Subject: [EXTERNAL]For Oct. 6 BAR meeting-Heritage Date: Sunday, October 3, 2021 6:25:34 PM

Subject: [EXTERNAL]Heritage project - BAR Hearing—October 6, 2021, Docket # 2021-00341-Letter Submission

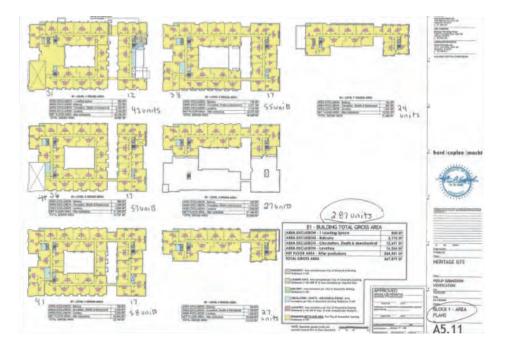
Extra height is not needed to retain 140 HUD units

Applicant's Floor Plans Used To Create The Above Charts

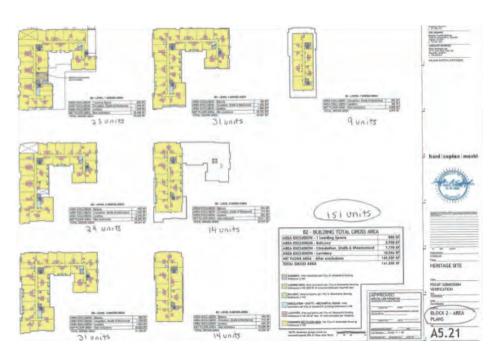
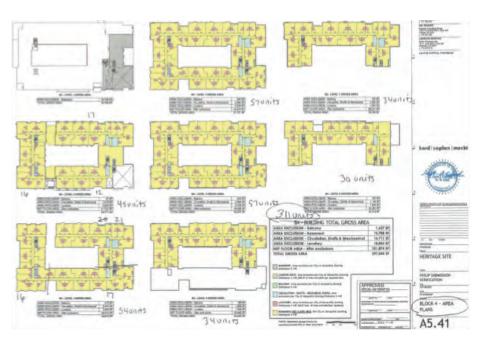
Using the applicant's floor plans (see next page), the units and square feet were allocated by building by floor.

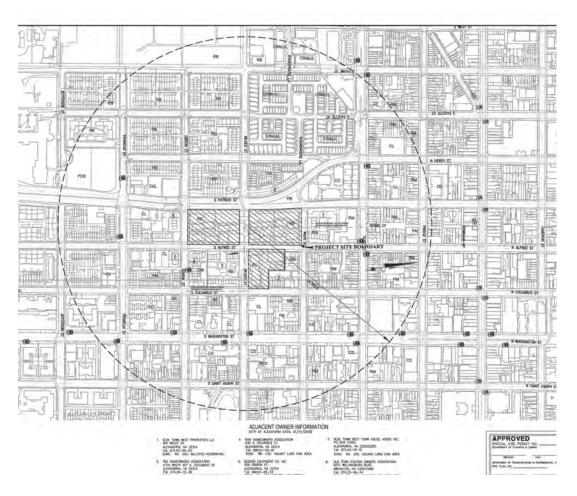
HEIGHT of +/–80 feet site plans exhibit noncompliance with RMF zone ordinance and Strategy ordinance.

HERITAGE DEVELOPMENT: BLOCKS 1 AND 2 OPEN SPACE

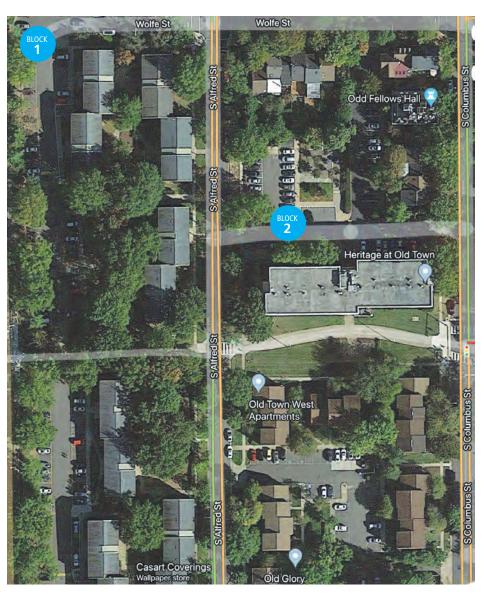
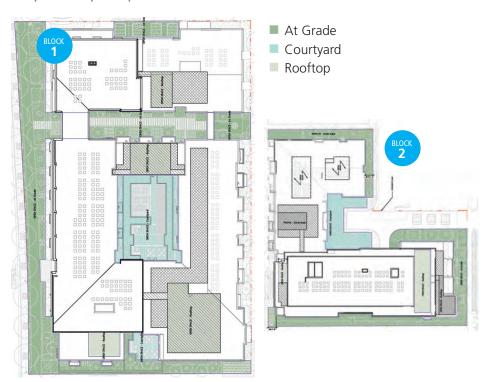
The project's mass is directly related to its site coverage. Based on the documentation submitted for the docket (Page 69) the site area of Blocks 1 and 2 is 207,158 SF (4.75 Acres) and the required Open Space is 51,790 SF (25% of the site area). From the existing Demolition Plans (Pages 62 & 64) the existing buildings cover about 29,940 SF leaving 85.5% of the site as open space. The Proposed buildings (Pages 74 & 76) would leave 42,330 SF as open space which includes rooftop and courtyard areas that are not appropriately considered open space. Since the proposed buildings would leave only 20.4% of the sites as open space the request for Appropriateness should be denied.

HERITAGE DEVELOPMENT: BLOCK 2 BUILDING HEIGHT

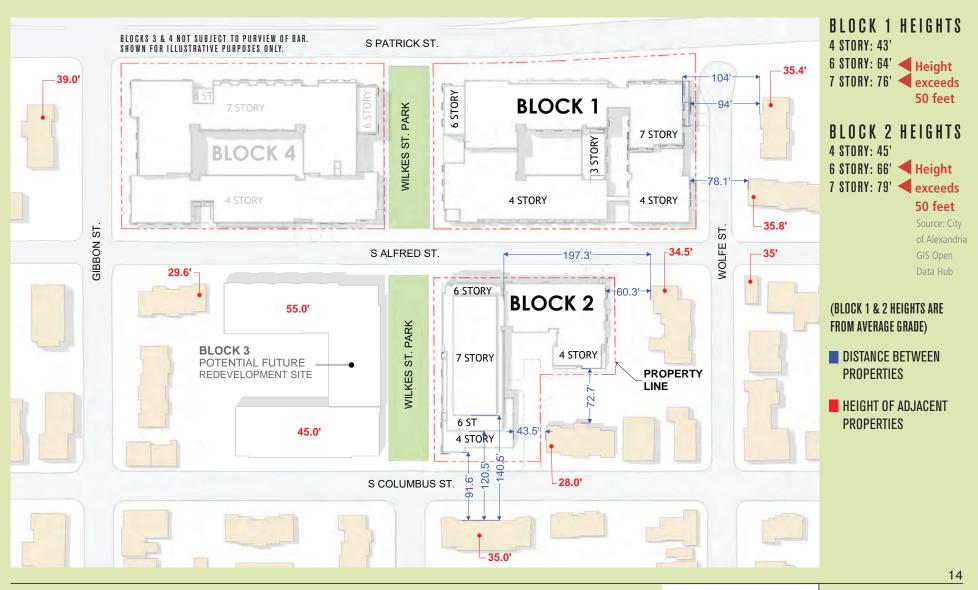
- **Zoning code 6–402** Old Town Height limit of 50 feet on Block 2—plans exhibit noncompliance with the height limit.
- Zoning code 6-403(A) Relationship to height setback in Old Town Height limit map —plans exhibit noncompliance to these setbacks.
- Zoning code 12–102 (B) Noncomplying structure expansions and reconstruction—plans exhibit noncompliance with these codes therefore building height cannot be prior building height before reconstruction.
- Zoning code 7–703—plans exhibit noncompliance with bonus height on building height 50 feet or less on Block 2.
- Sec. 8–200 (A) (2) (a) (ii)(i)(B) and (C) Plans exhibit noncompliance with required minimum garage parking space requirements. Walkability Index calculation therefore ineligible for 10% parking garage reductions requested.

HERITAGE DEVELOPMENT PLANS: BLOCK 4

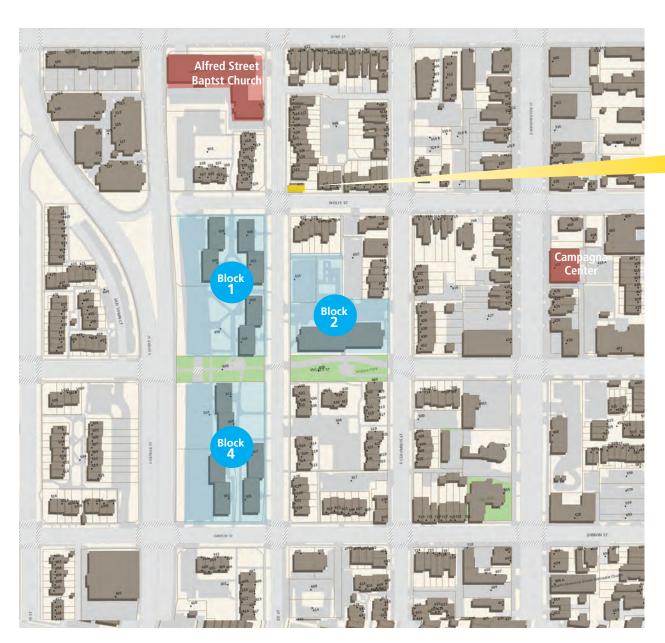
- Building height, mass & scale is dominating the neighborhood of 2–3 story townhouses.
- Not compatible with existing neighborhood character.

THE HERITAGE DOMINATES AND IS INCOMPATIBLE WITH NEIGHBORHOOD
